## INDIANA DEPARTMENT OF TRANSPORTATION

# APPROVED MINUTES

**January 18, 2018 Standards Committee Meeting**

RE: Minutes from the January 18, 2018 Standards Committee Meeting

## 805-TSCS-02 TRAFFIC SIGNAL CANTILEVER STRUCTURE SINGLE SIGNAL ARM POLE ELEVATION, DIMENSIONS, AND BASE PLATE WELD DETAIL (WITH MARKUPS)

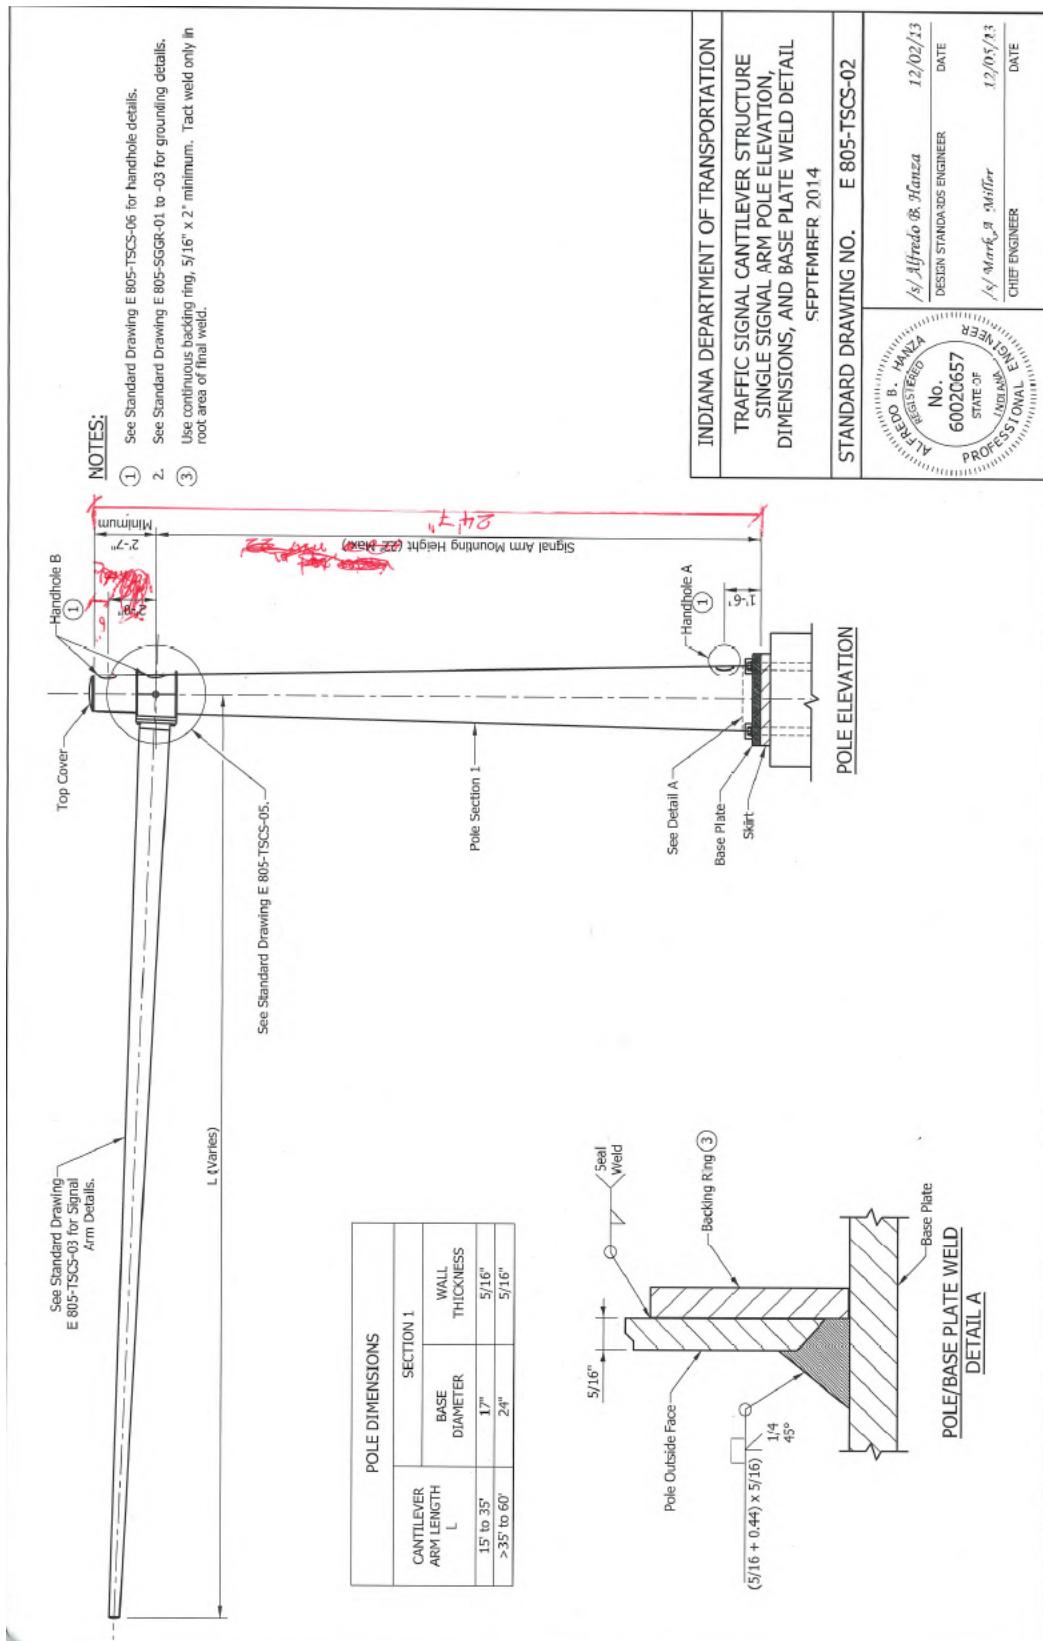
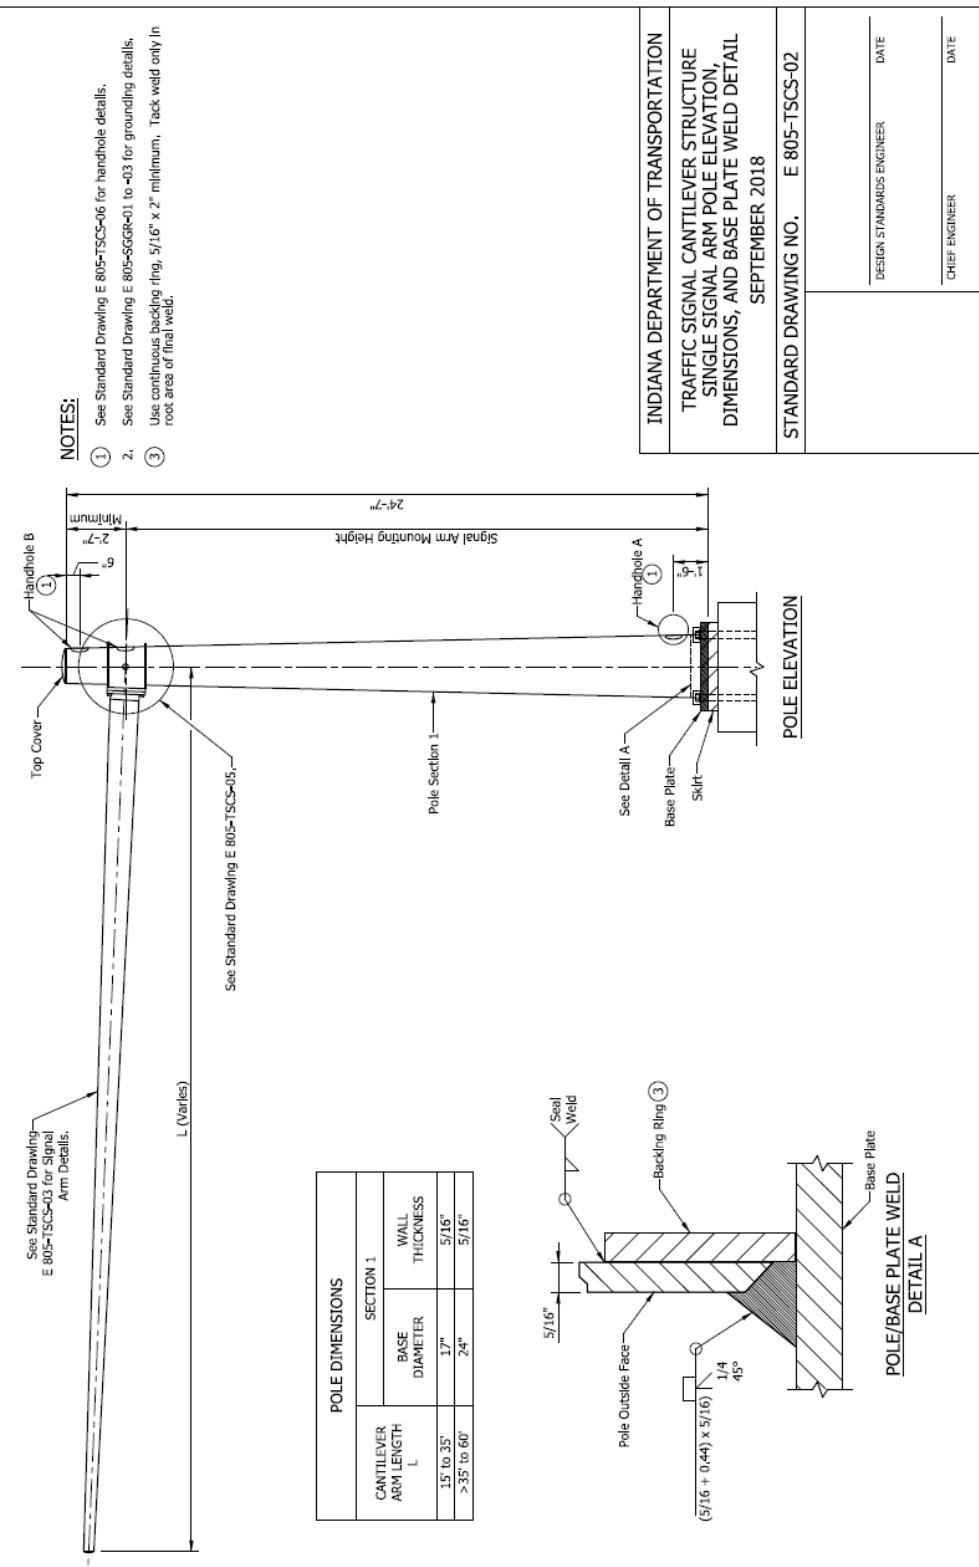
PROBLEM(S) ENCOUNTERED: Two of the dimensions in the standard drawing for a single arm traffic signal cantilever structure are incorrect. The signal arm mounting height can exceed 22 ft but hand hole B must be 6 in. from the top cover.

Mr. Bruno introduced and presented this item stating that two of the dimensions in the standard drawing for a single arm traffic signal cantilever structure are incorrect. The signal arm mounting height can exceed 22 ft but hand hole B needs to be 6 in. from the top cover.

PROPOSED SOLUTION: Correct the dimensions on the standard drawing relating to the signal arm mounting height and hand hole B.

Mr. Bruno therefore proposes to correct the dimensions on the standard drawing relating to the signal arm mounting height and hand hole B, as shown.

## 805-SGCF-03 SIGNAL PEDESTAL FOUNDATION TYPE A (WITH MARKUPS)

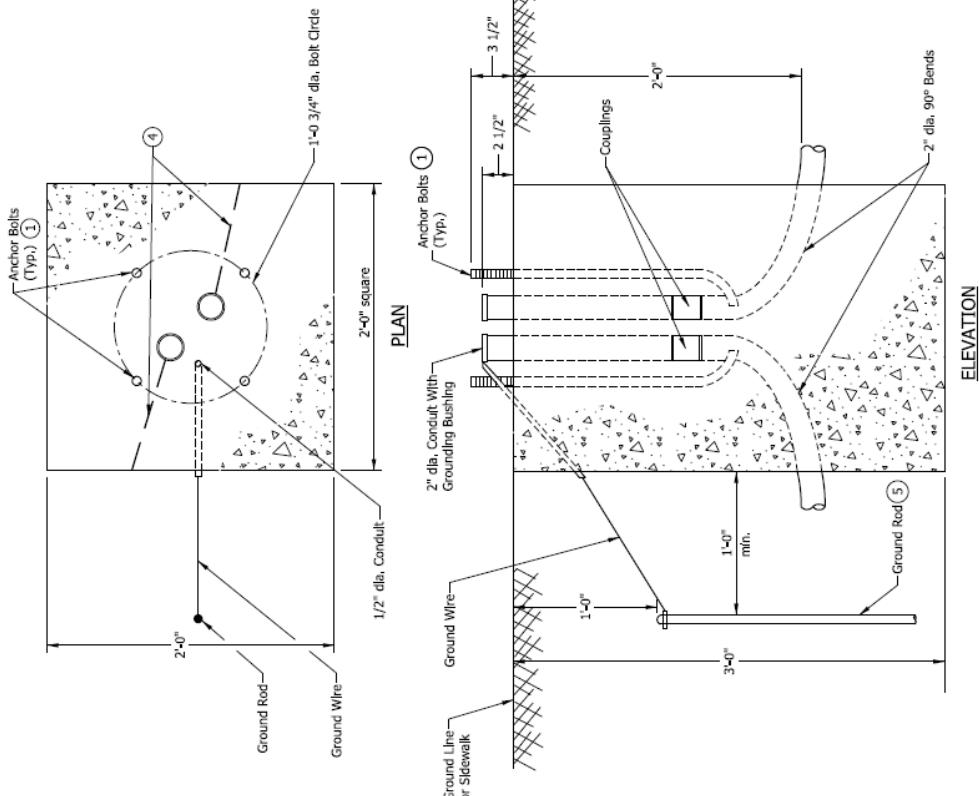
PROBLEM(S) ENCOUNTERED: The standard pay items for the signal pole foundations are now based on the size of the foundation. However, the standard drawing for the signal pedestal pole foundation refers to it as a type A foundation.

Mr. Bruno introduced and presented this item stating that the standard pay items for the signal pole foundations are now based on the size of the foundation. However, the standard drawing for the signal pedestal pole foundation refers to it as a type A foundation. Mr. Bruno therefore proposes to revise the title of the standard drawing and add a note to reference the older terminology. These revisions are as shown above.

PROPOSED SOLUTION: Change the title of the standard drawing and add a note to reference the older terminology.
